Product Change Notification (PCN)

Overview

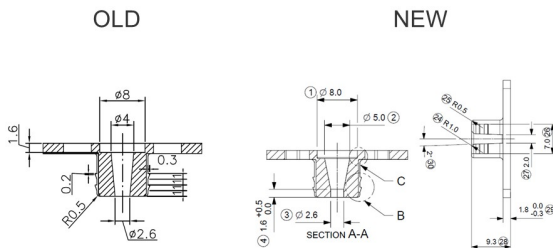
- To improve quality of the product, Molex decided to slightly change design of following gaskets.
- Product Impact
 - Slightly changed dimensions
- Part Number Impact
 - 1211240160
 - 1211240161
 - 1211240188
- Qualification Reports and samples available upon request after the date shown above
